PROJECT: Chesterwood Village Phase 2: Light Care Assisted Living and Main Street
8073 Tylersville Rd.
West Chester, Ohio 45069

**Correction Letter Response #2: BCDES Plan Review 4-19-07, Public Water Main Extension at Chesterwood Blvd.
Application # BLD-CT07-00729**

BCDES Plan Review 4-19-07, Public Water Main Extension at Chesterwood Blvd., EPA Application

PARTIAL REVISED B/1-5
8" PUBLIC WATER MAIN EXTENSION

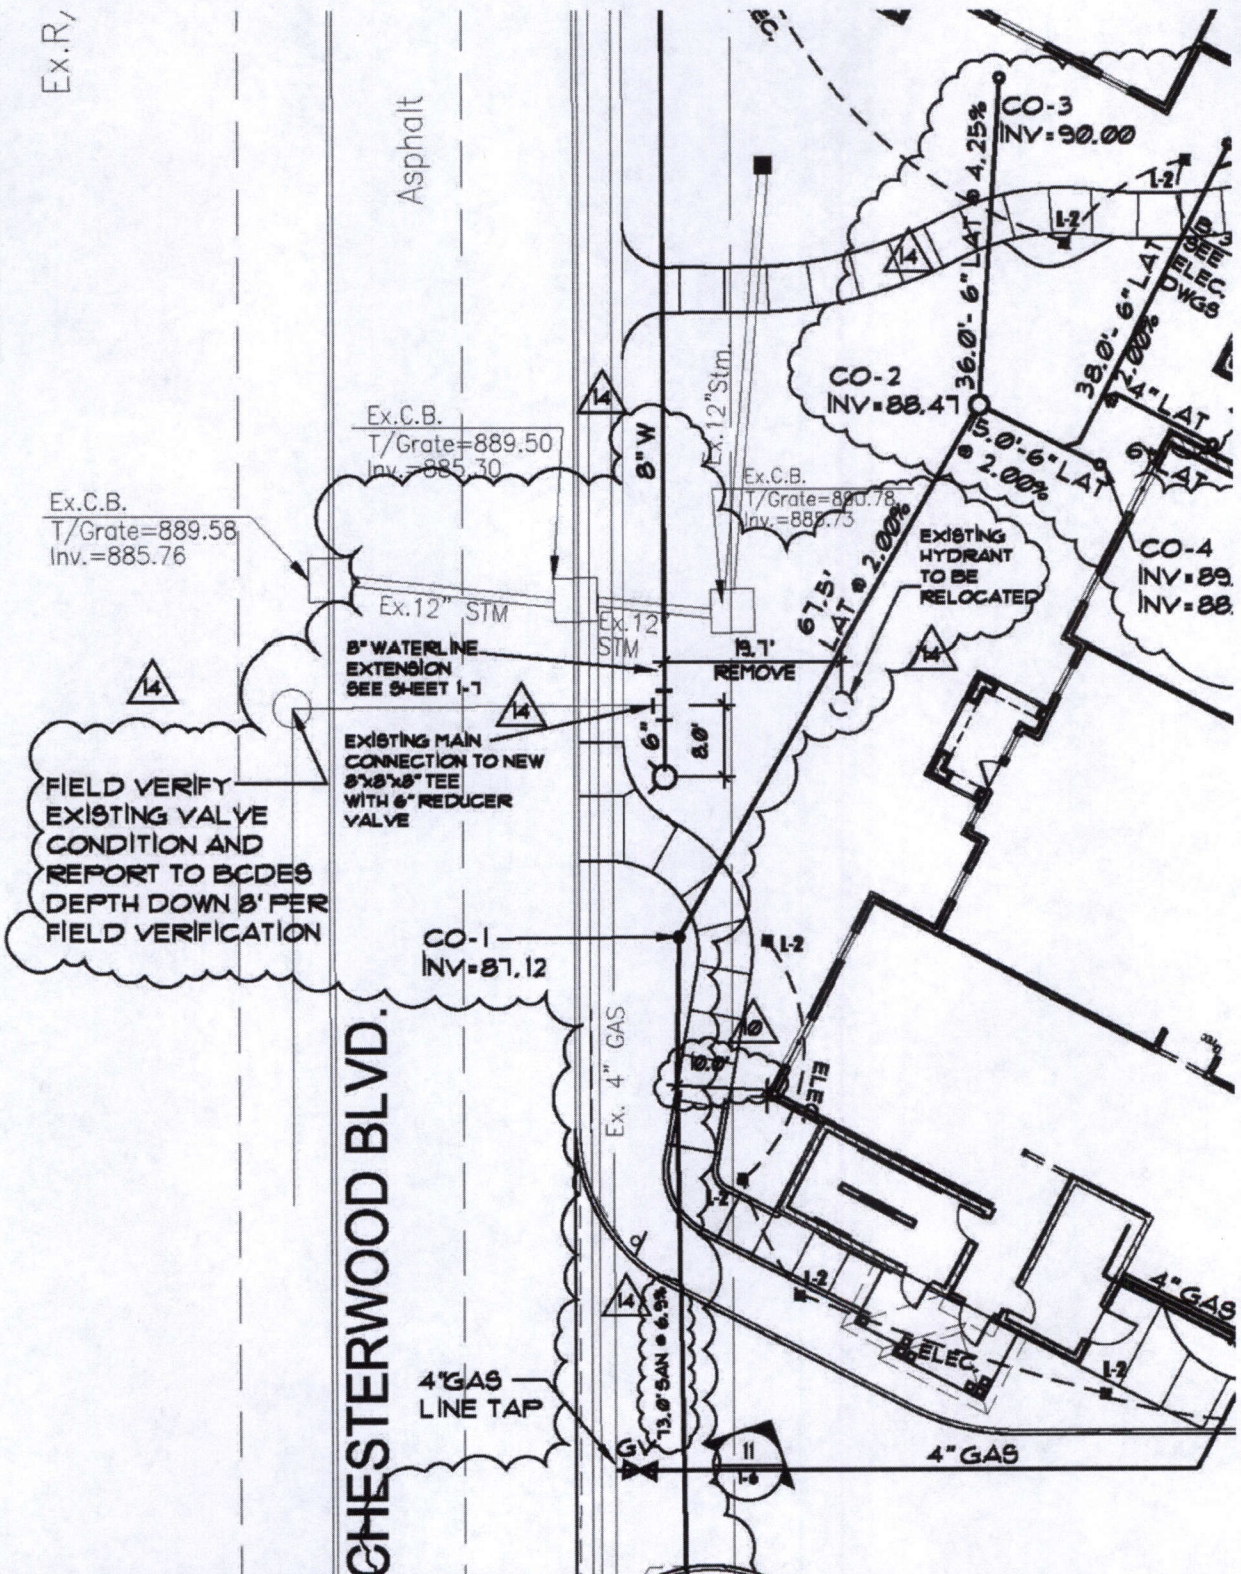
Review Response #5&6: BCDES requested 8" Public Water Main Extension

The existing public 8" water line that crosses Chesterwood Boulevard has been altered within the easement of the east side of the road. The existing hydrant shall be relocated at a new "tee" connection as indicated, extending the public water line north to a temporary hydrant location near Tylersville road.

See the attached excerpt drawings ASI1-6A through ASI1-6E from ASI#1, revised Sheet B/1-5 drawing and water profile section A/1-7.
Full size sheets have been included for the EPA Application indicating this information.
